## Fwd: CH 25 comments

From: Hannes Stueckler <hannes.stueckler@wyo.gov>  
Date: Mon, Feb 4, 2013 at 5:07 PM  
Subject: CH 25 comments  
To: William Tillman <william.tillman@wyo.gov>

To: Bill Tillman  
 From: Ronald Ewald, Assistant Southeast District Engineer  
 Water Quality Division, Wyoming DEQ  
 Date: February 27, 2013  
 Subject: **DRAFT2 Chapter 25 – Comments, Questions, and Concerns**

FIGURE 1

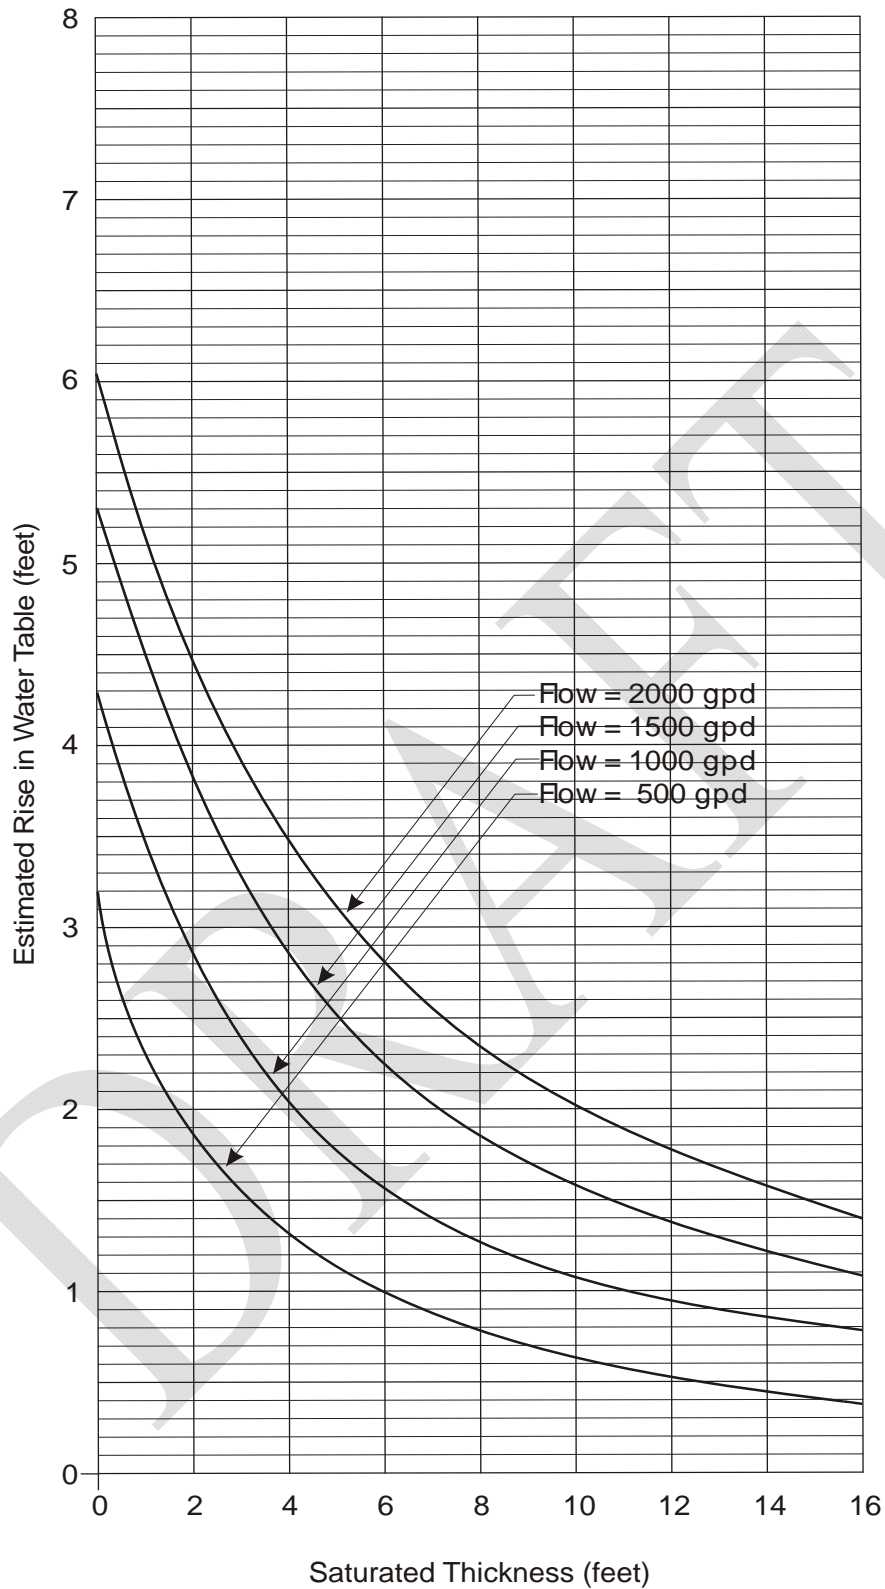
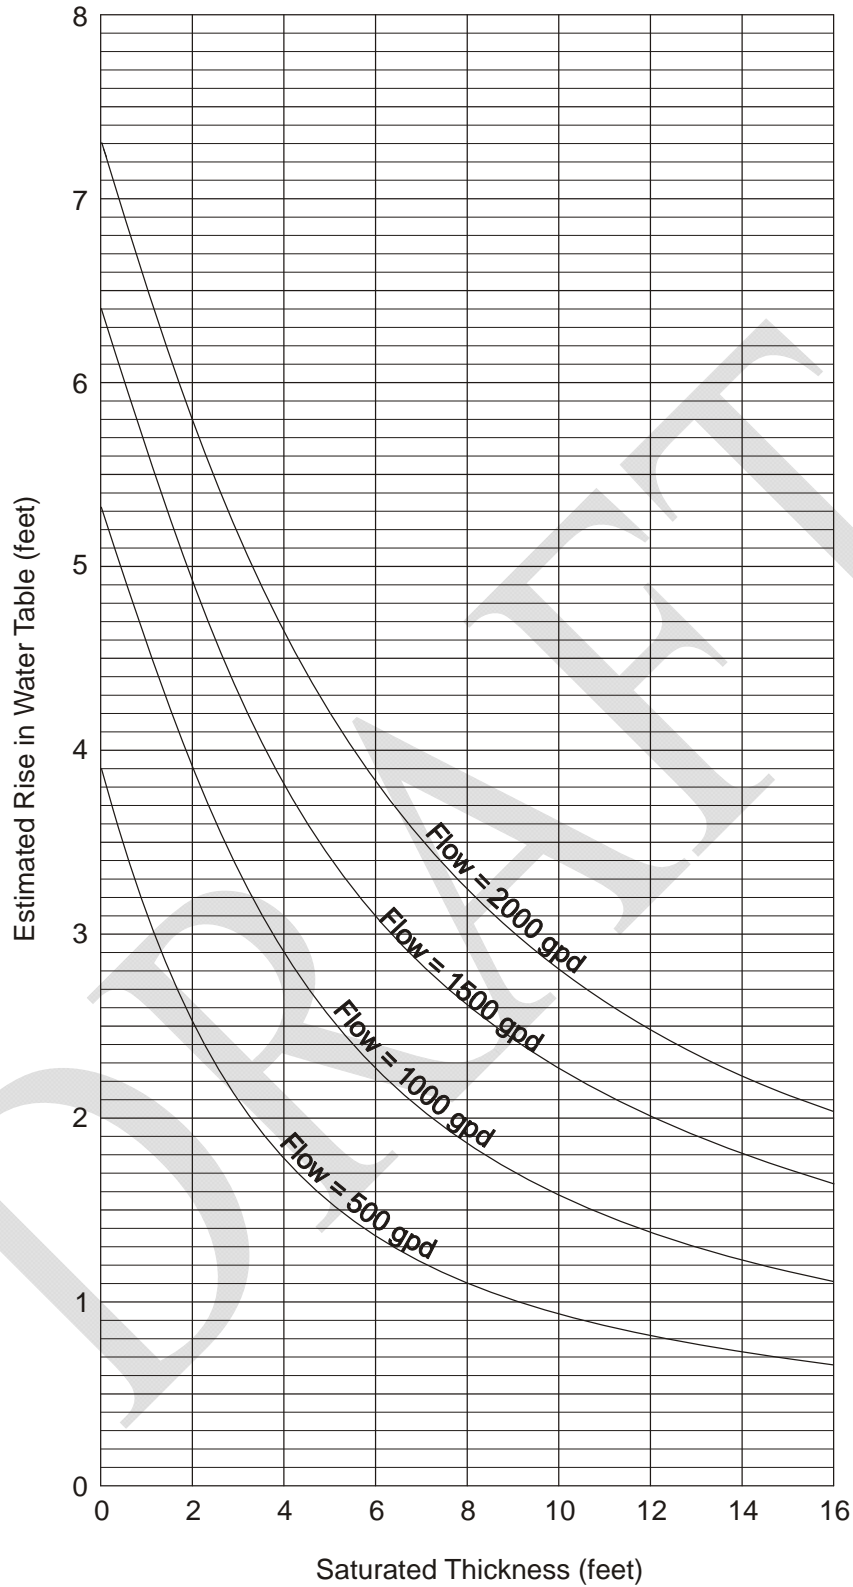
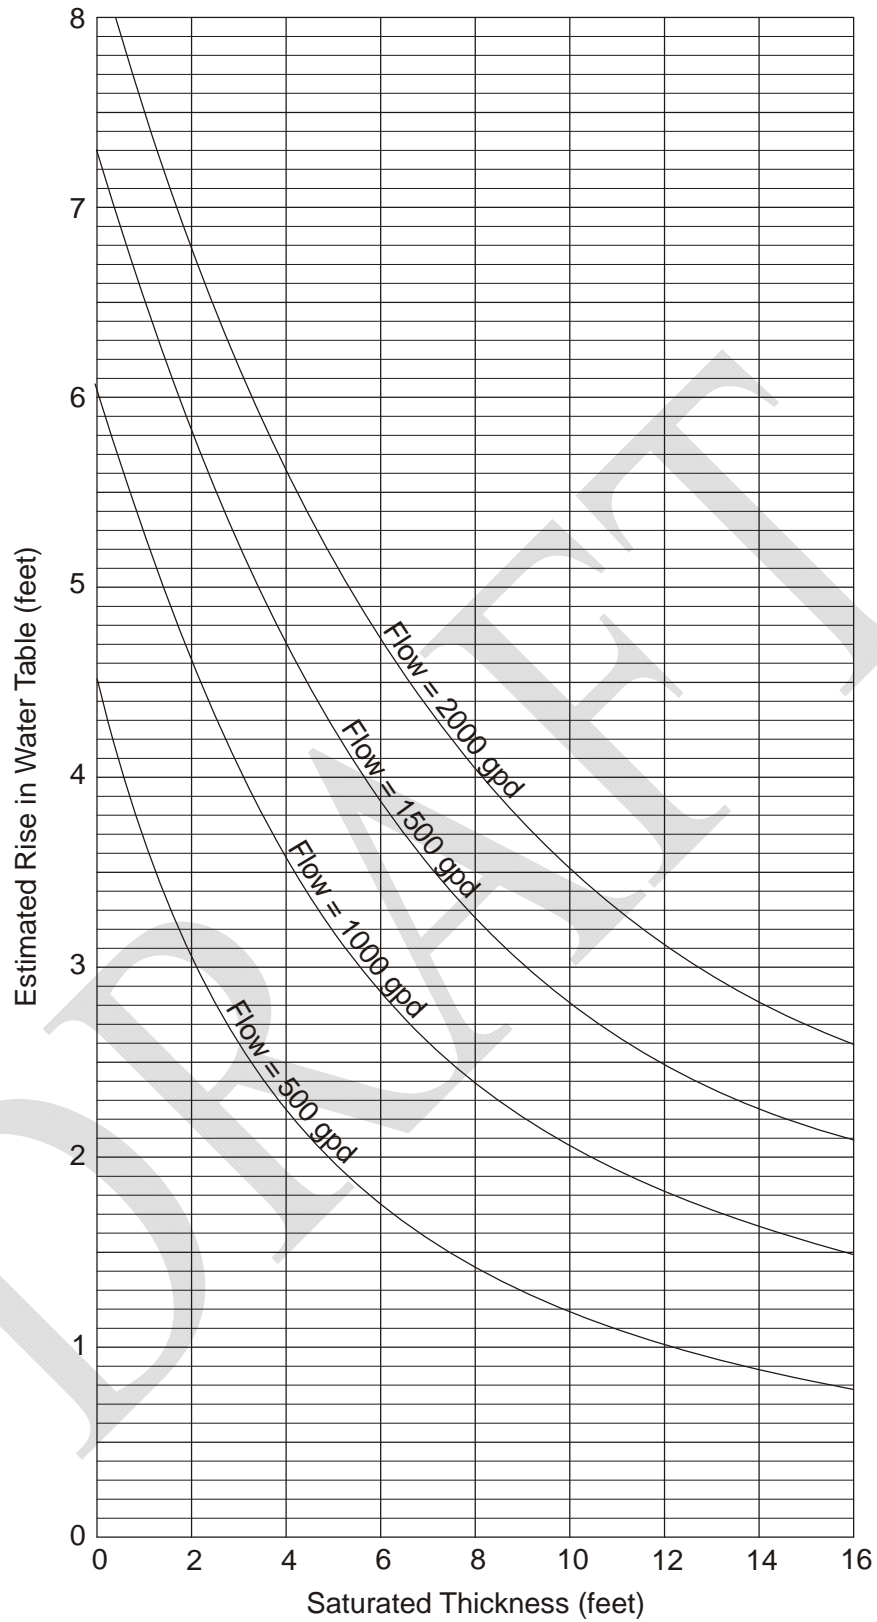
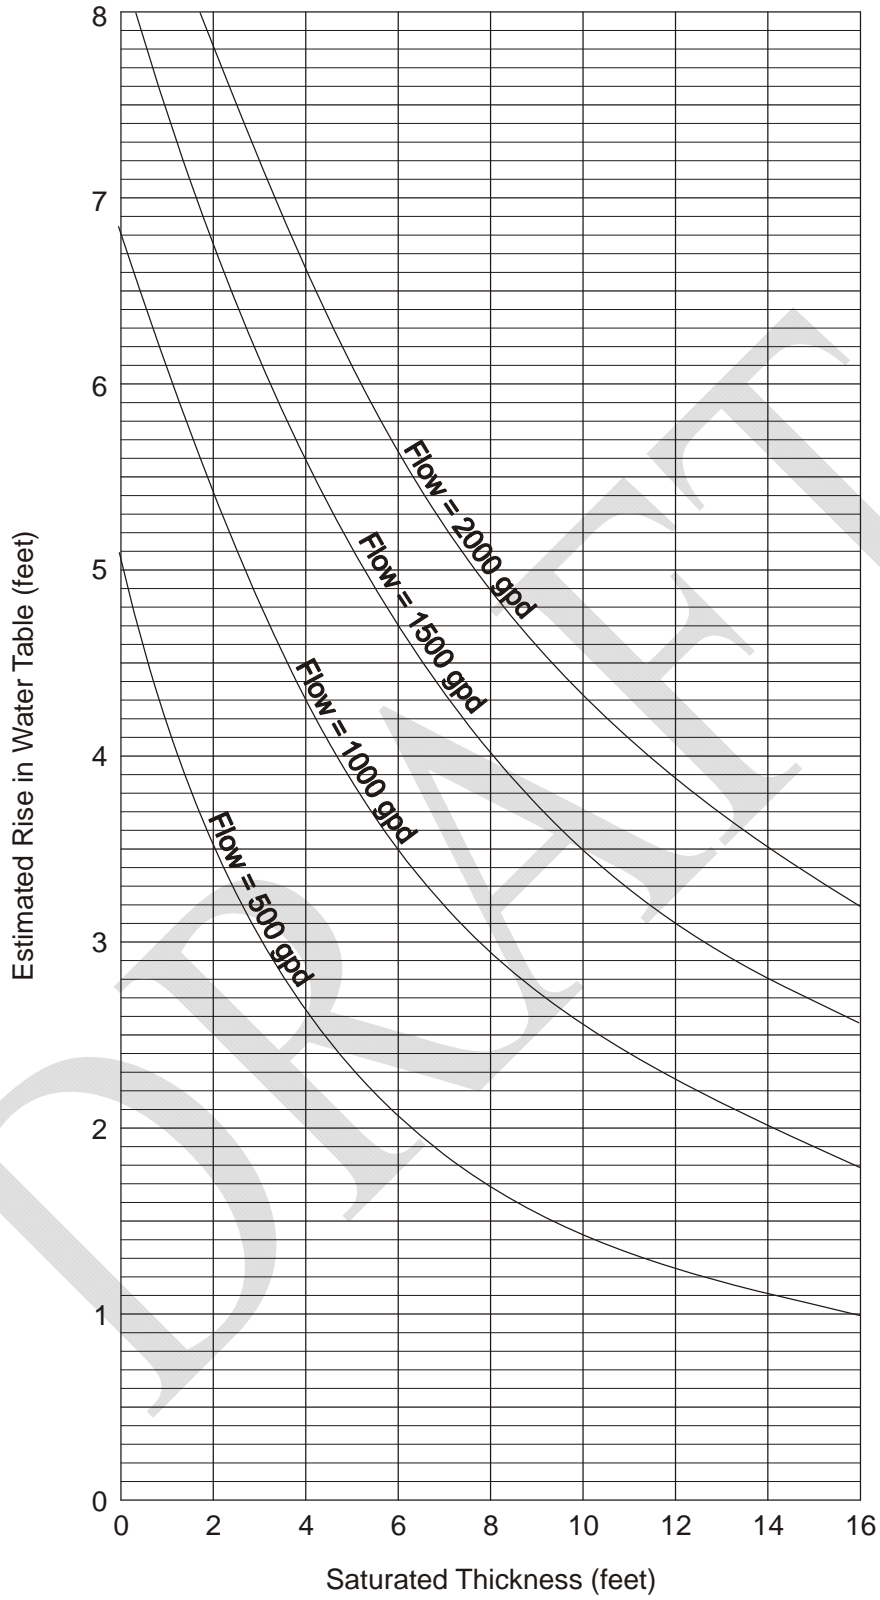
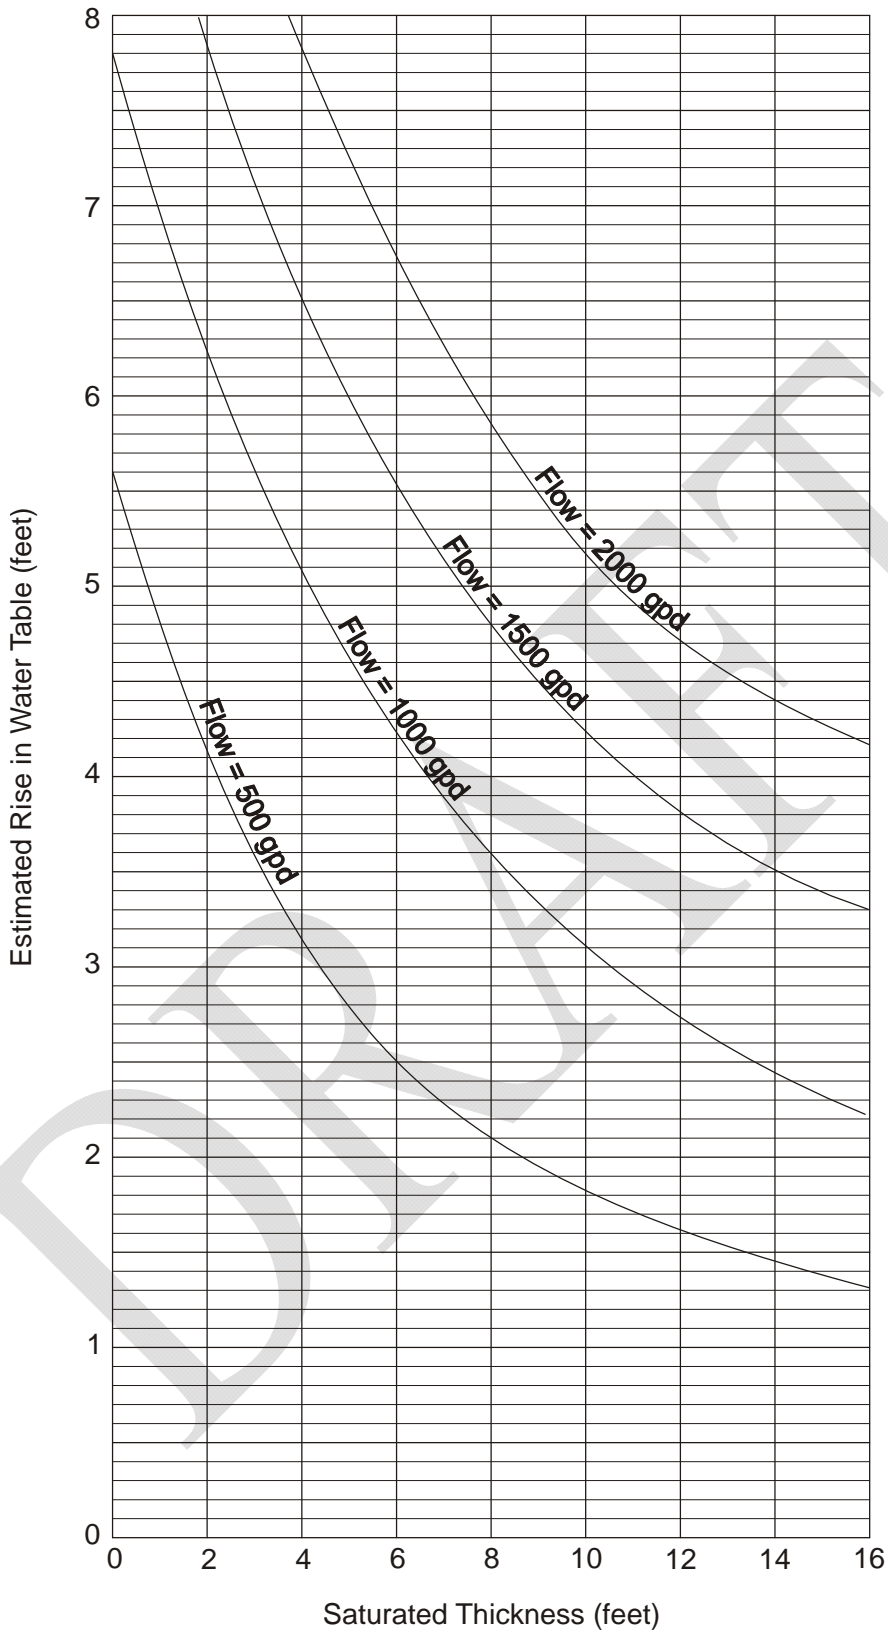
A graphic would be helpful for this item.
